Ref: WTJQ24-061

**RE: RESPONSE TO INFORMATION REQUEST - A006651694
51 CROSSACRES STREET, DOOLANDELLA QLD 4077**

- Development Permit for Reconfiguring a Lot (1 Lot into 23 and common property)

Figure 1. Approx. outline of area marked for Low density residential (orange on Figure b of NP code)

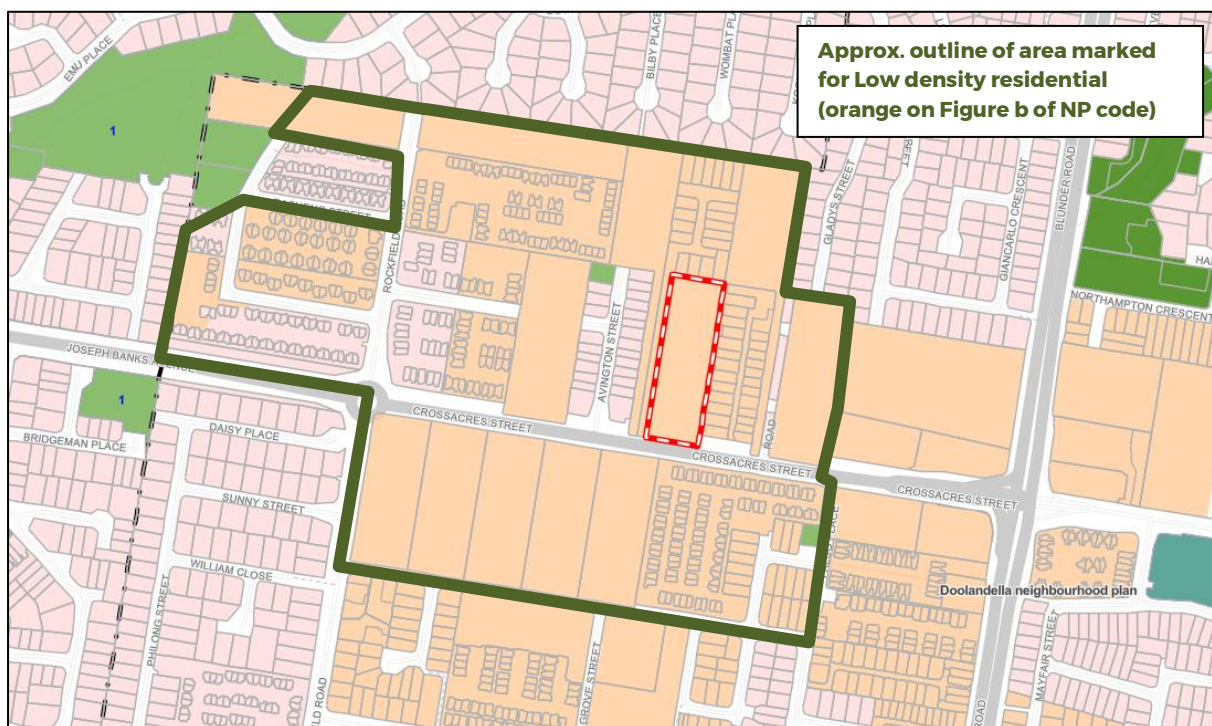
- 3) *The site is included in the Doolandella neighbourhood plan, Potential development area – Low density residential. The neighbourhood plan nominates a maximum density of 12 dwellings per hectare, therefore the maximum density expected for the site is 12-13 dwellings. The 23 lots proposed significantly exceeds the expected density outcome for area. This density is also proposed in combination with majority small lots below the minimum requirement, and only 1 standard lot at 465m².*
- a) *Submit revised plans with minimum lots sizes, in accordance with AO1.1/PO1 of the Subdivision code.*
 - b) *Submit a building envelope plan as per AO27.1 / PO27 of the Subdivision code.*

The Applicant acknowledges the site and surrounding properties are within the area annotated for Low density residential – dwelling houses under Figure a of the Doolandella neighbourhood plan code. As shown, this area is primarily in the Emerging community zone and there have been some significant recent developments in the area evidenced by the lot outlines on Figure 1 below.

The Applicant notes overall outcome 3f of the Doolandella neighbourhood plan code prescribes predominantly dwelling houses at a yield of 12 dwellings per hectare, and not a maximum. As such, any exceedance of this number is not automatically inconsistent with the overall outcome.

The Applicant also observes that as shown in Figure 1 above, there have been significant developments nearby and within the area identified on Figure a. The Applicant notes the following examples of approvals in close proximity to the Site, all at densities materially exceeding a yield of 12 dwellings per hectare:

These approvals establish that the local character and density expectations in this part of Doolandella have evolved beyond the nominal density contemplated by the neighbourhood plan. The approved developments in the immediate vicinity reflect a density pattern that is broadly consistent with the proposed density and is considered to be suitable for the site.
